ACCESSION NBR: 8004010330 DOC. DATE: 80/03/19 NOTARIZED: YES DOCKET #
 FACIL: 50-220 Nine Mile Point Nuclear Station, Unit 1, Niagara Powe 05000220
 AUTH. NAME: AUTHOR AFFILIATION
 DISE, D.P.: Niagara Mohawk Power Corp.
 RECIP. NAME: RECIPIENT AFFILIATION
 EISENHUT, D.G.: Division of Operating Reactors

SUBJECT: Forwards info re primary coolant pressure isolation capability as per 800223 request. Info demonstrates that continued operation of facility does not present undue safety hazard to public.

Re: Nine Mile Point Unit 1
Docket No. 50-220
DPR-63

WASH-1400, EVENT V
(LOSS OF PRESSURE ISOLATION)

CONTROL ROD DRIVE HYDRAULIC SYSTEM
FIG. OP-5-1

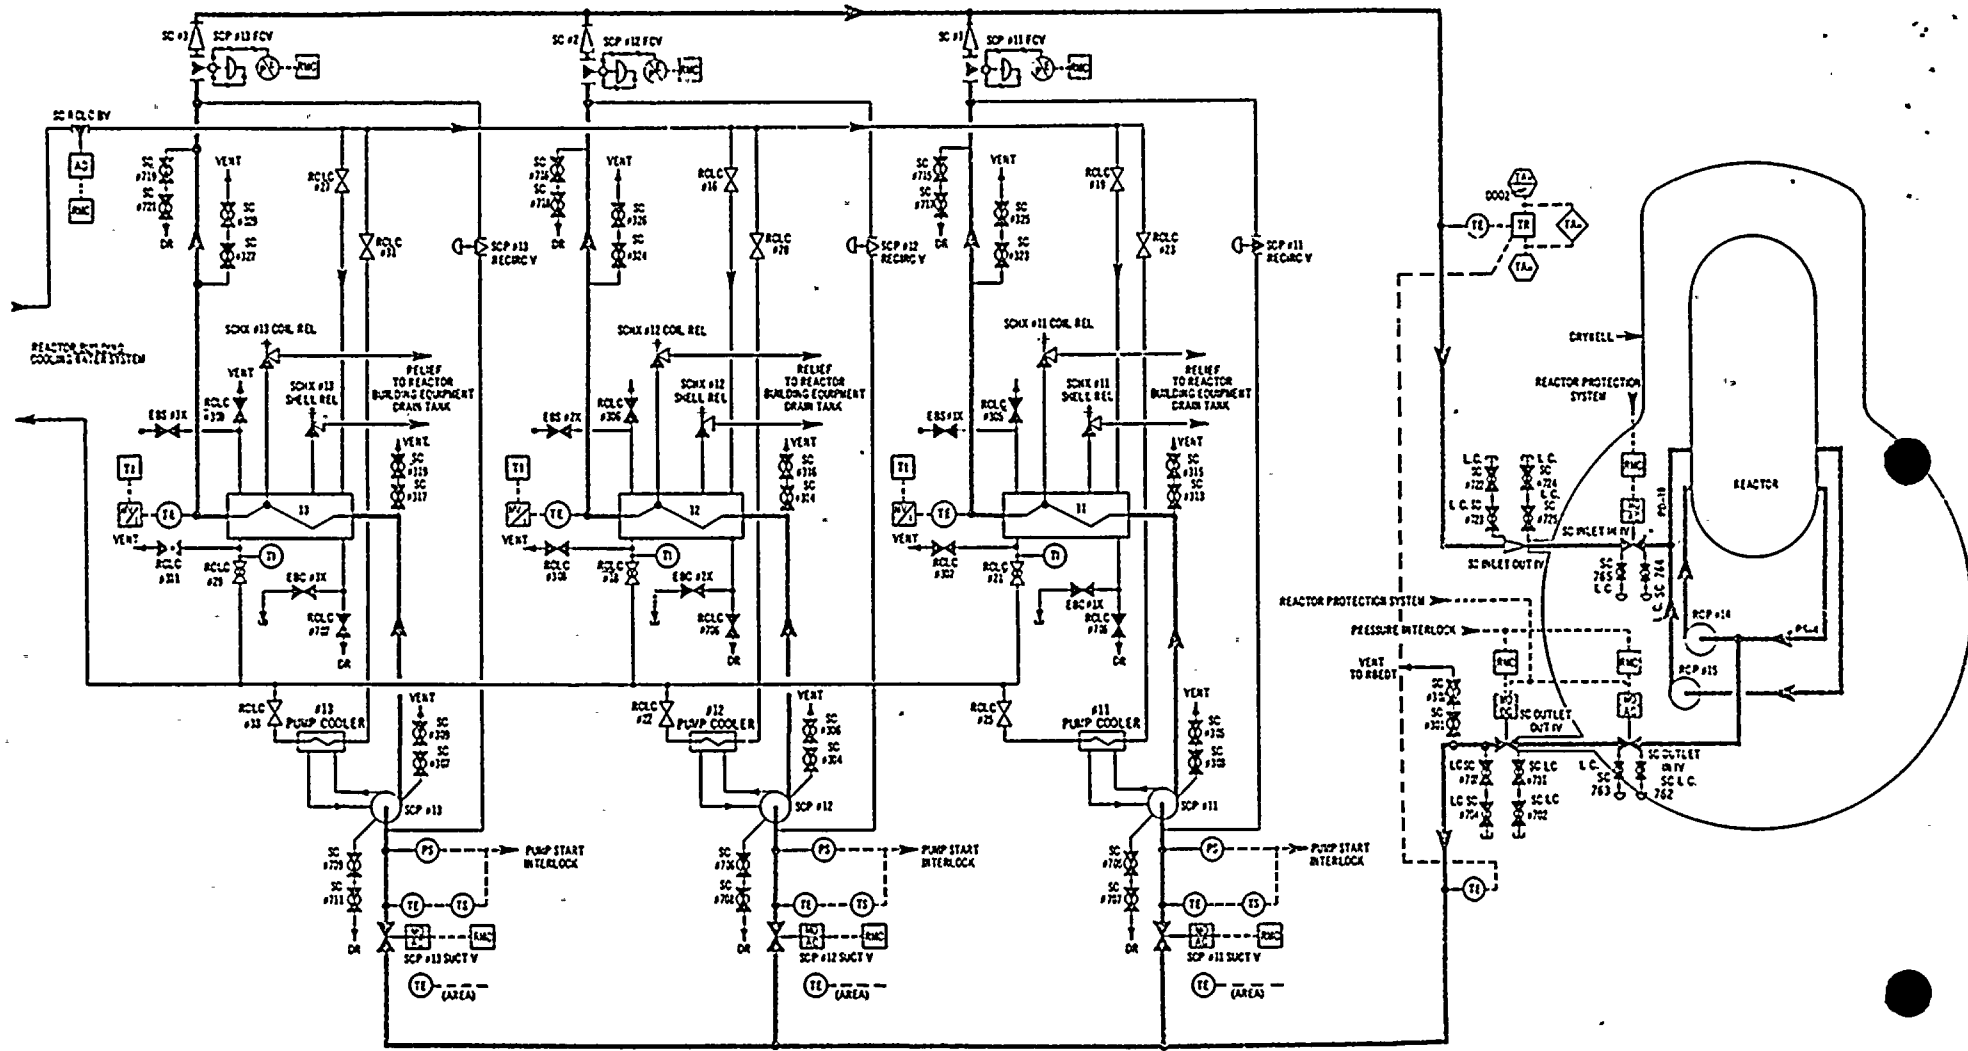
The control rod drive system has two check valves in series. However, this system is a high pressure system from the reactor vessel back to and including the control rod drive pumps. In addition, there are motor operated valves between the check valves and the pumps which could be used for isolation.

LIQUID POISON SYSTEM

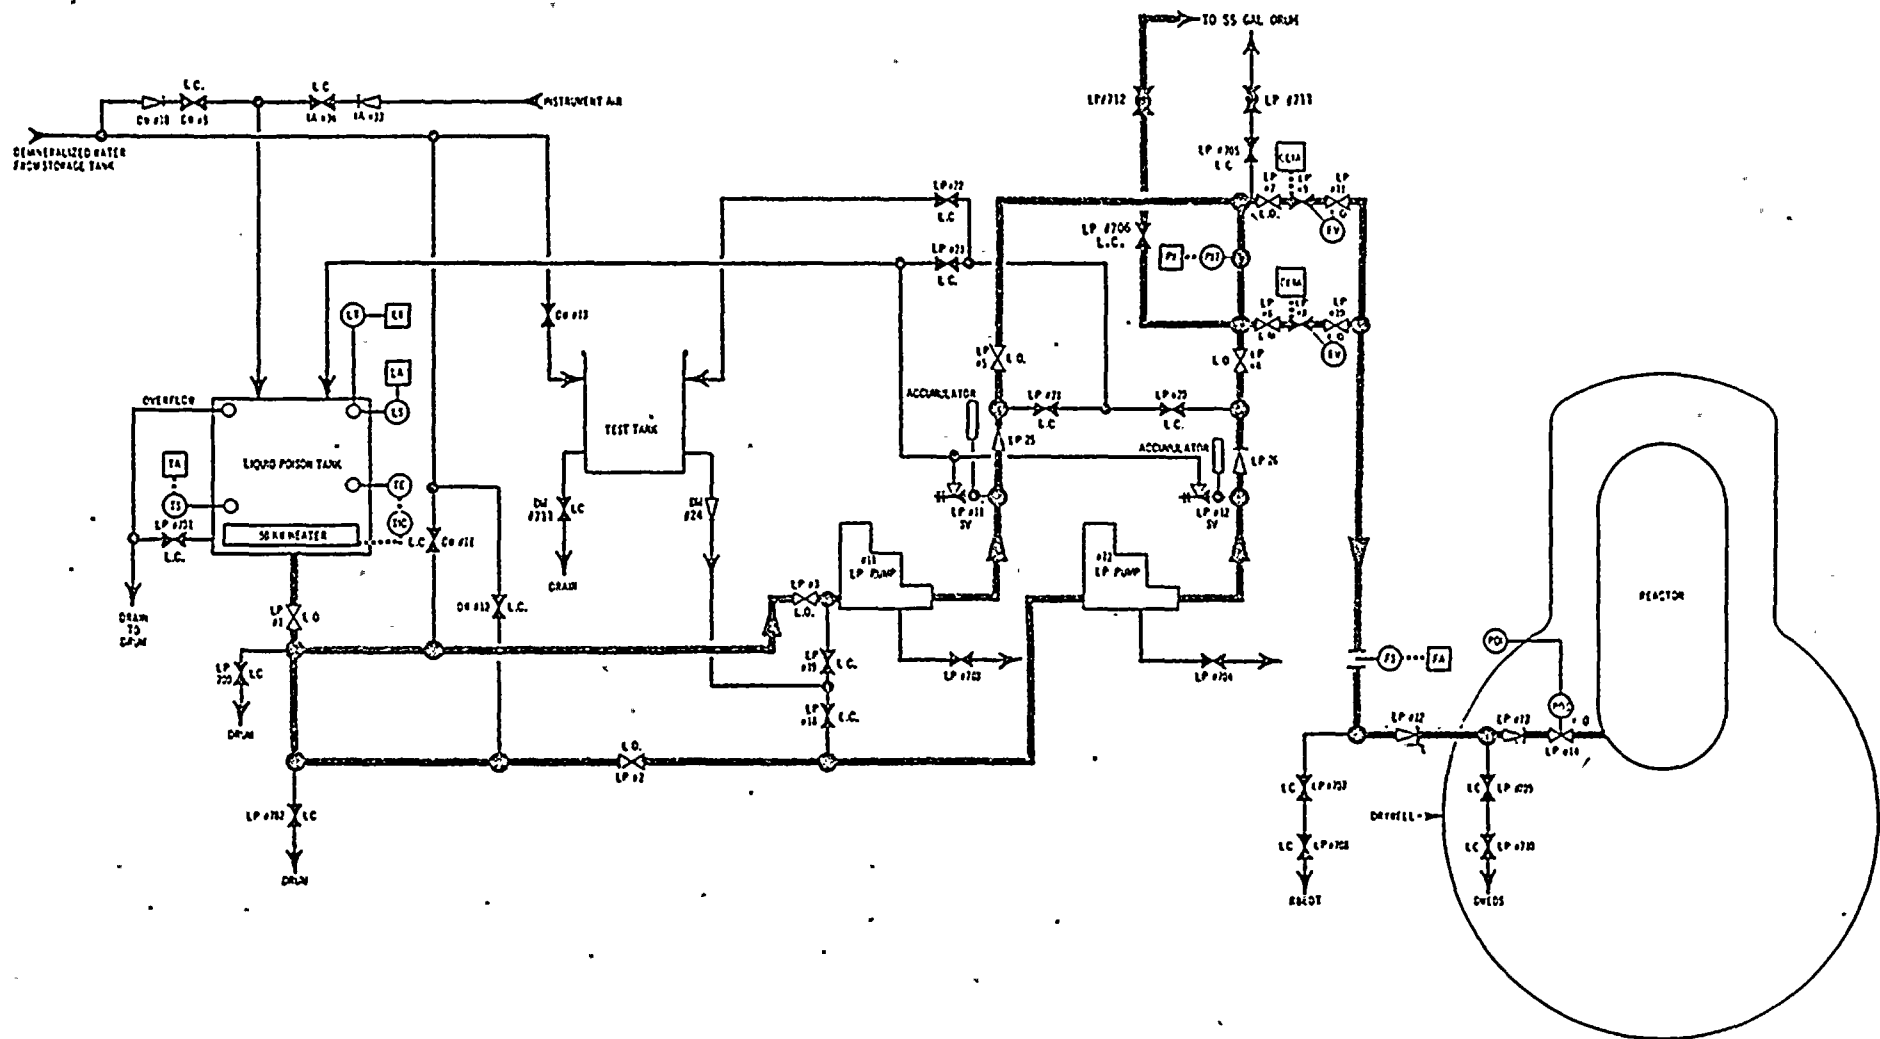
The liquid poison system is designed for reactor pressure from the reactor vessel back to and including the positive displacement pumps. This system contains two check valves in series. However, there is a normally closed explosive valve and another check between that configuration and the pumps.

HEAD SPRAY SYSTEM
FIGURE OP-4-2

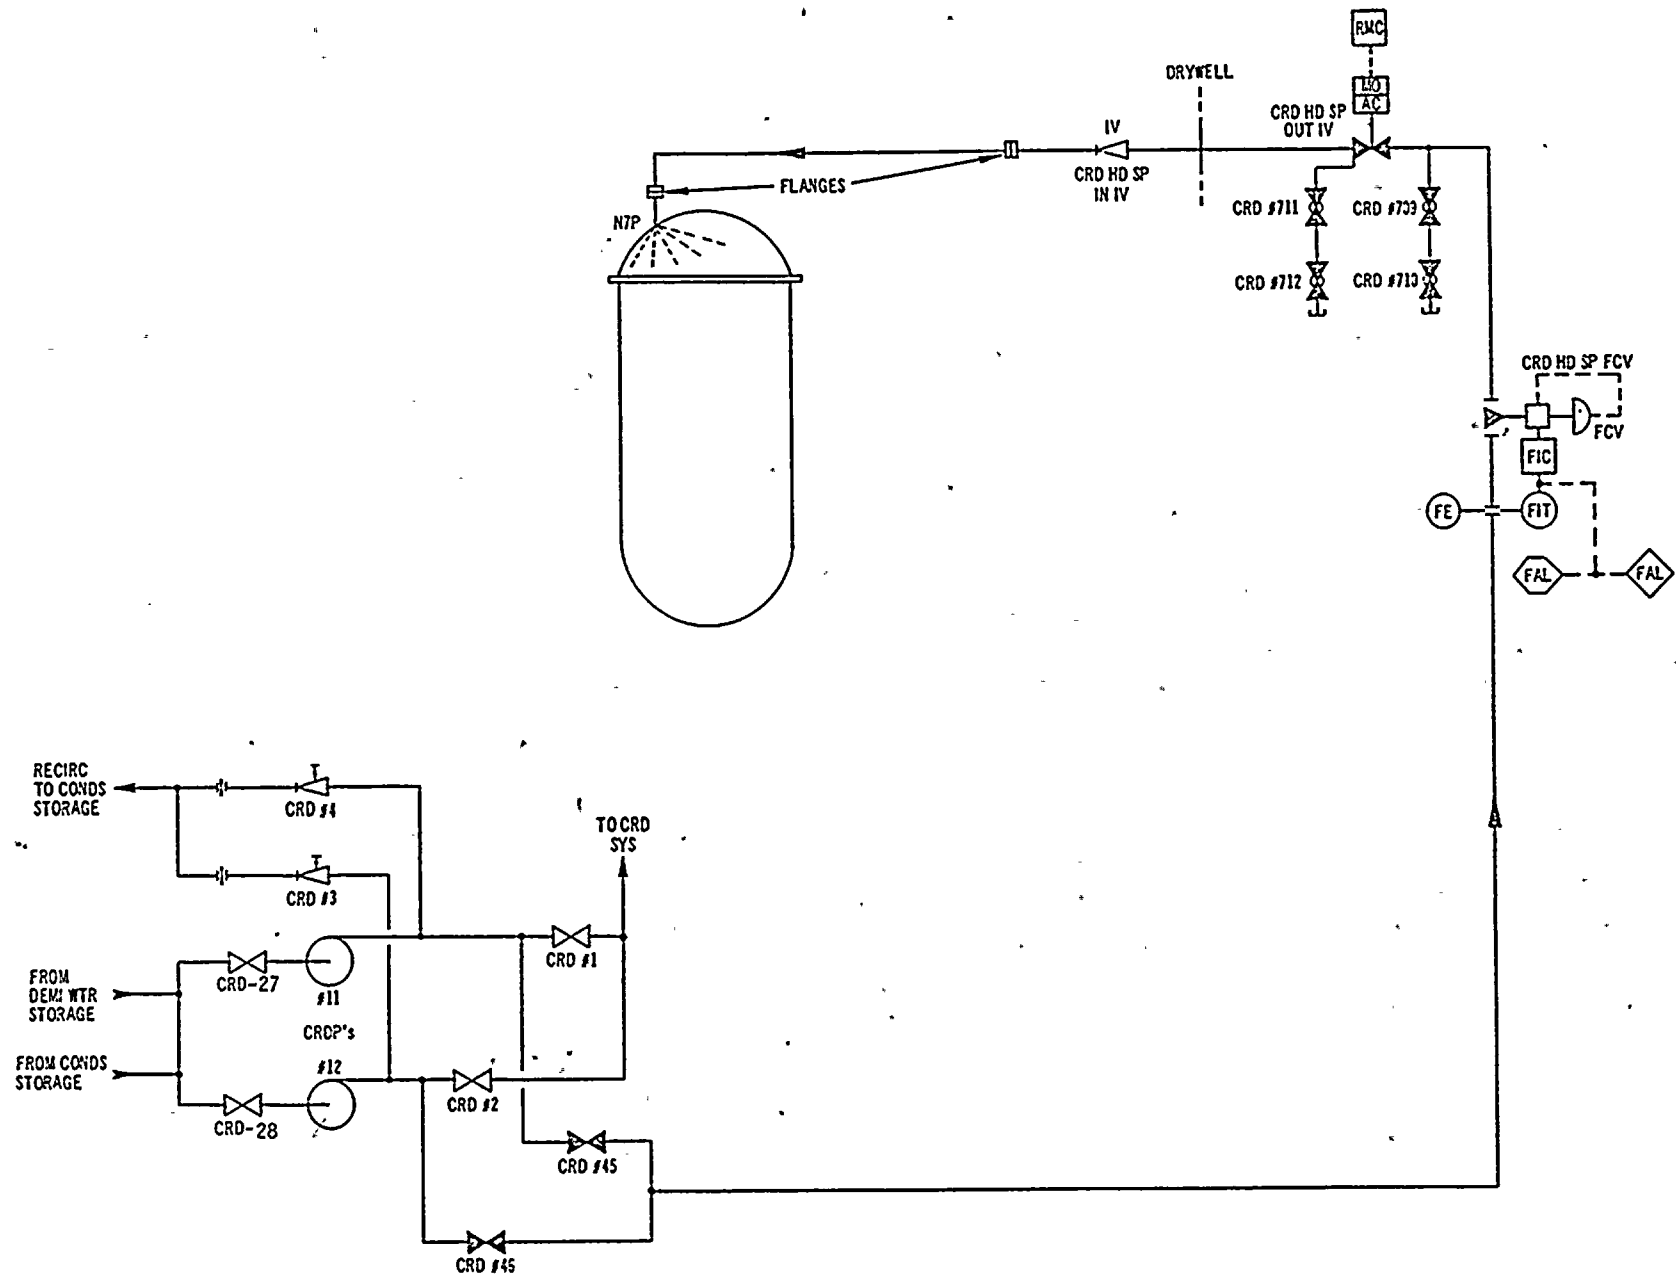
The head spray system is designed for reactor pressure from the reactor vessel back to the control rod drive pumps. This system has a check valve in series with a normally closed motor operated valve, a flow control valve and a normally closed gate valve. The system is not used during power operation.

NUCLEAR STEAM SYSTEM
FIGURE OP-1-1
9-1-75

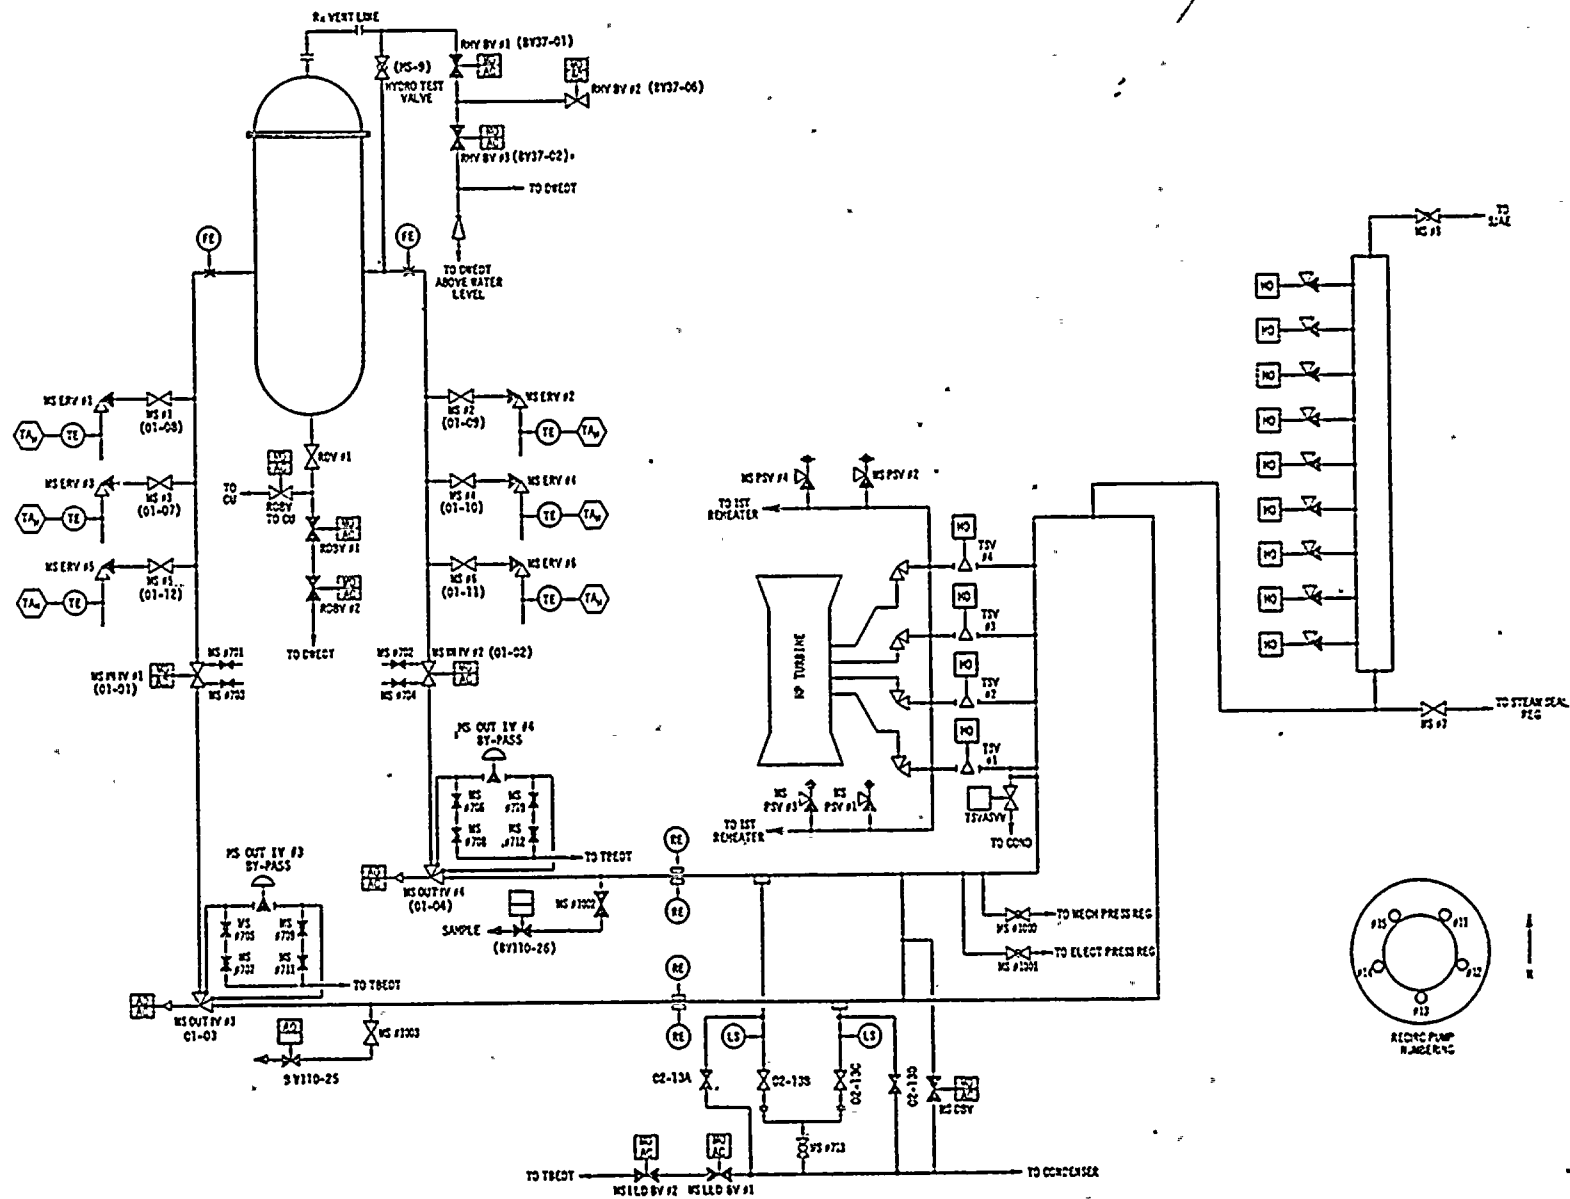
The main steam system is designed for reactor pressure up to the high pressure turbine. Two check valves in series are not relied upon in this system.
